Project:
SHADOW ANALYSIS REVIEW
NO 10 ONSLOW AVE & 21C BILLYARD AVE
ELIZABETH BAY NSW
CLIENT: DARNLEY HALL PTY LTD

**Objection to a Development Application: D/2023/727 - Revised.
No.10, Onslow Avenue and No.21C, Billyard Avenue,
Elizabeth Bay - Residential Flat Building
Visual Impact Assessment Report: Revised Scheme, July 2024**

UPDATED FOR NEW PLANS

DWG TITLE
HEIGHT PLANE EXCEEDANCES O
DWG NO REV
DA008 B

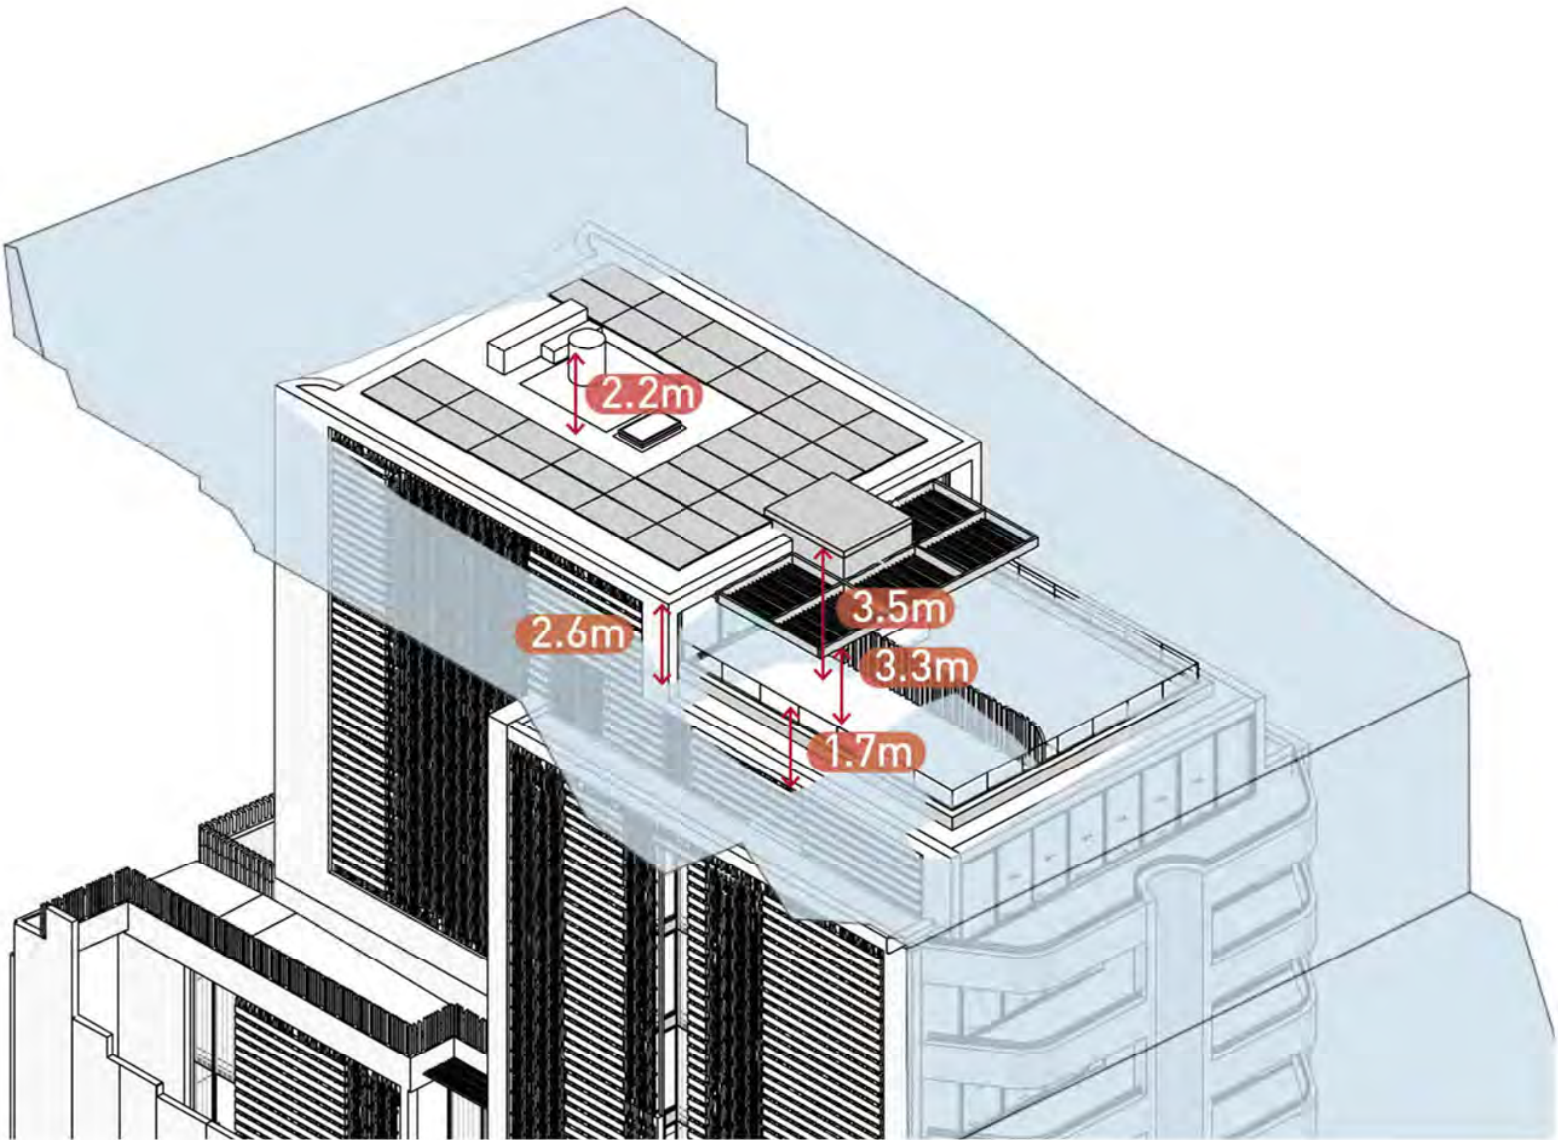
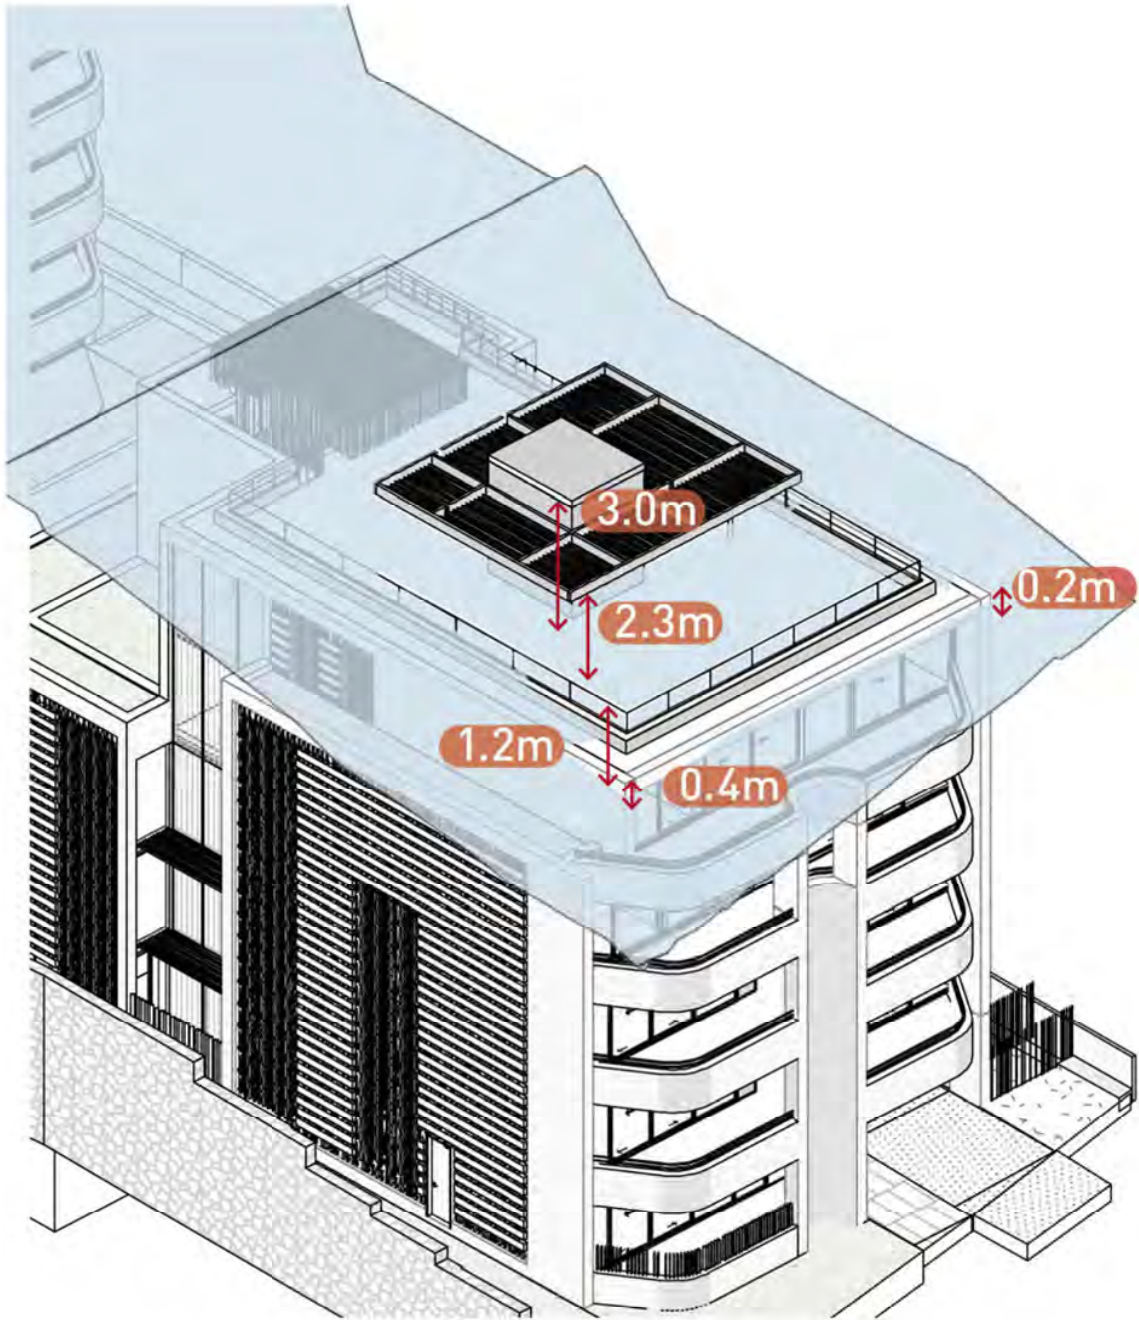
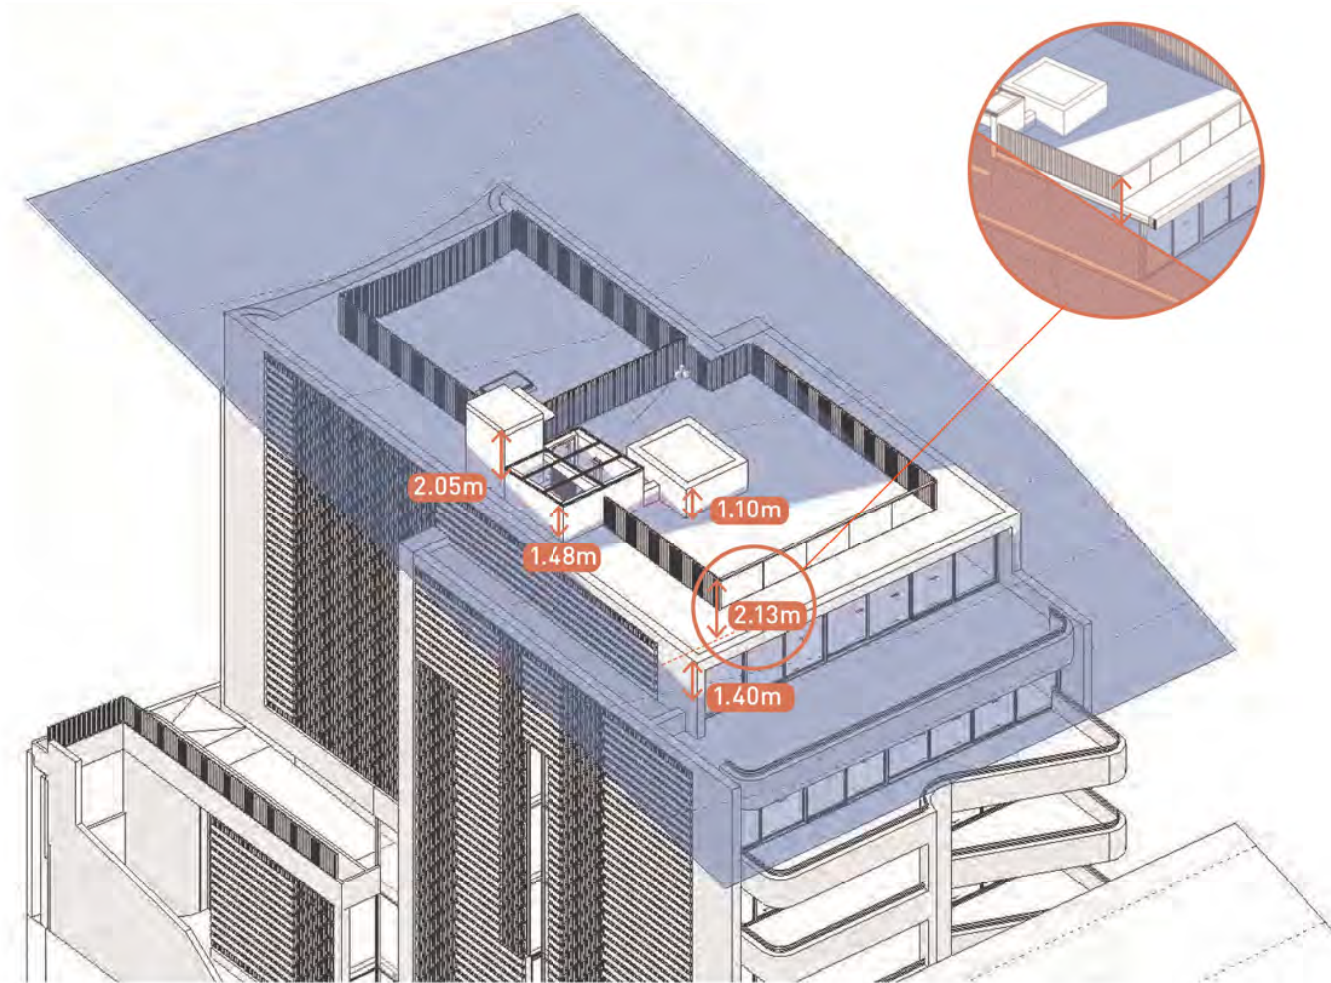
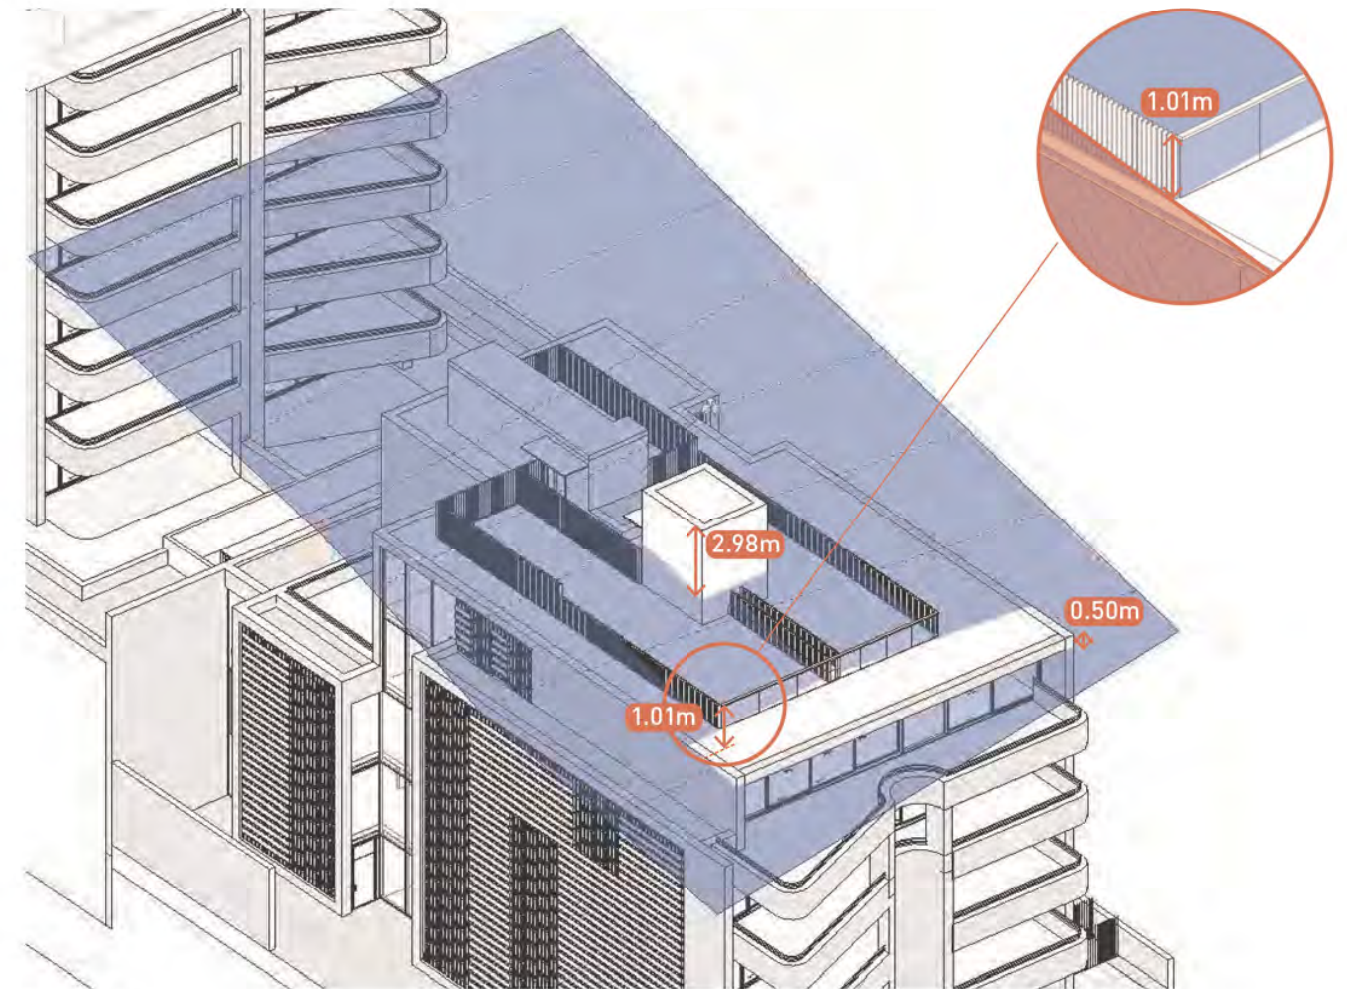
Height plane exceedance in Onslow building is caused by penthouse lift overrun, stair access retractable cover / skylight, main lift overrun, fences and balustrades. North-East corner of the form exceeds height plane by 1.4m. Building form was extended to achieve feasible apartment size and layout. To minimize exceedance glazing line was pushed back.

Billyard building rooftop accommodates communal open space, therefore lift and stair access was required. Lift overrun exceeds height plane by 2.98m. North edge minimally exceeds height plane by max. 0.5m.

None of exceeding elements (lift overrun, stair access, balustrades, and fences) is visible from street level.

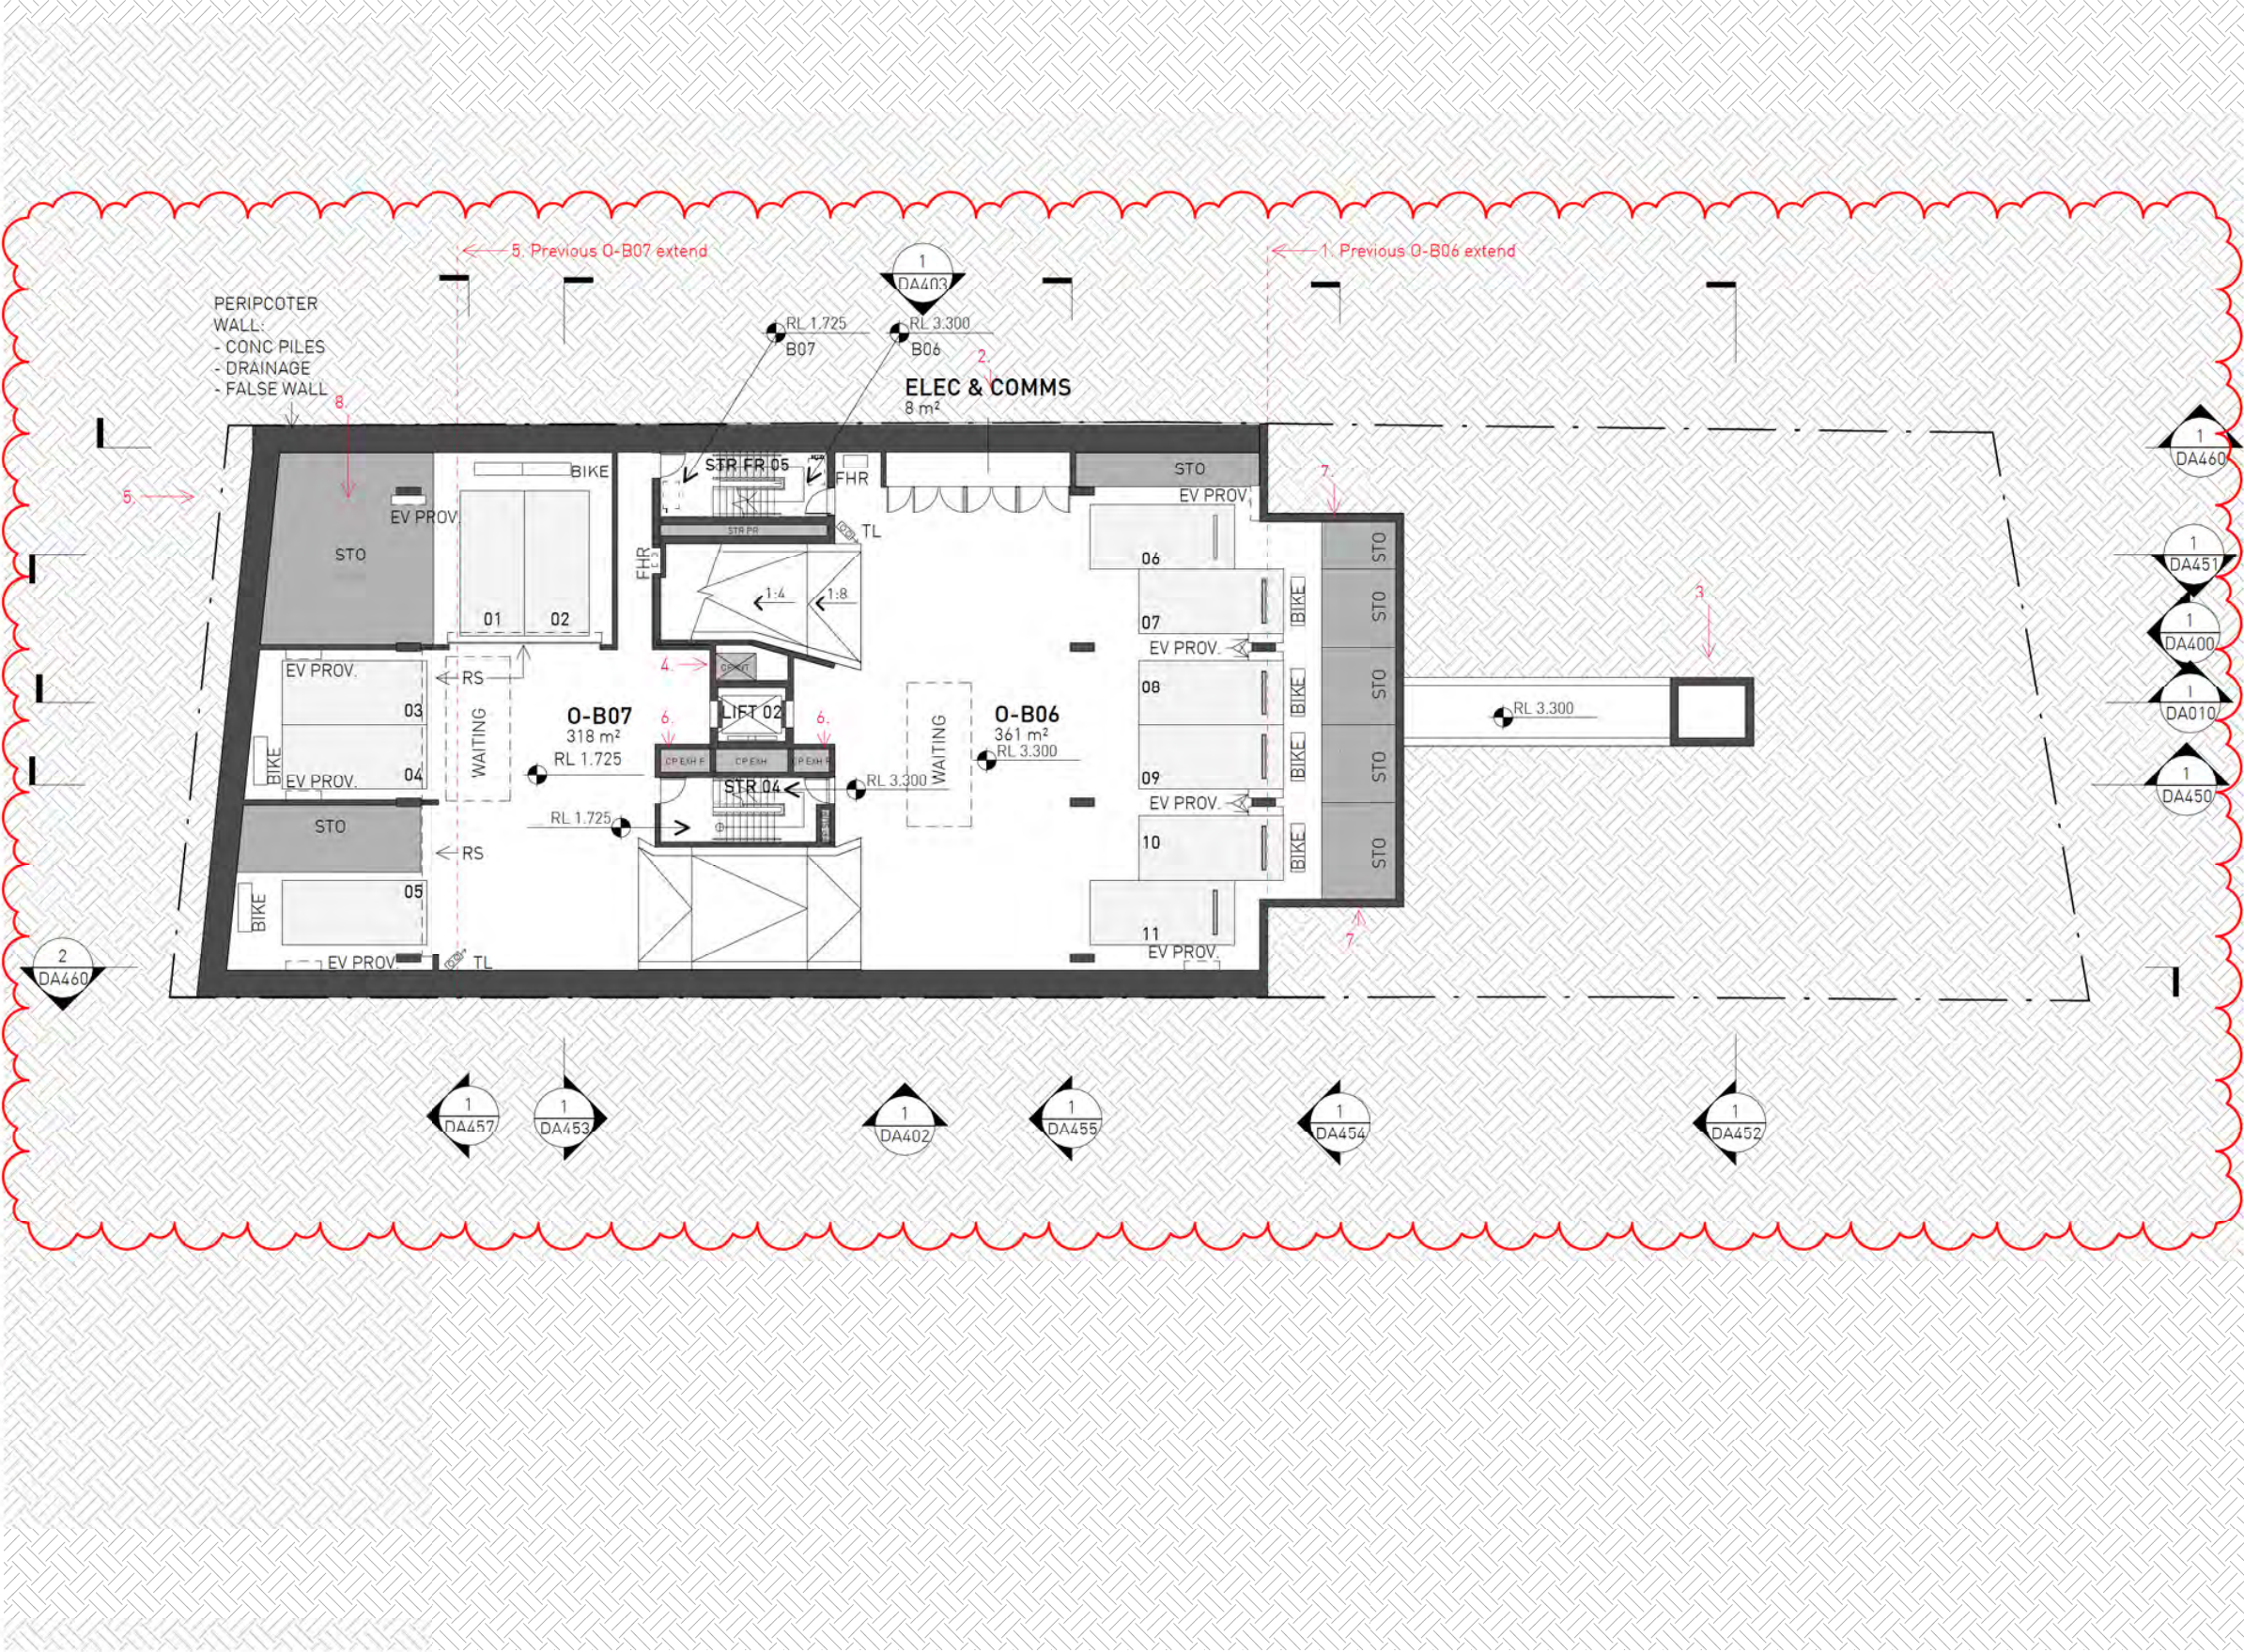
- 1. O-B06 basement extended.
- 2. Elec & Comms cabinet relocated.
- 3. Lift 01 (Billiard building) extended to O-B08 level.
- 4. Waste chute removed.
- 5. O-B07 basement extended.
- 6. Carpark EXH fans relocated from roof.
- 7. Basement extend changed to provide more deep soil.
- 8. Storage added to garages.
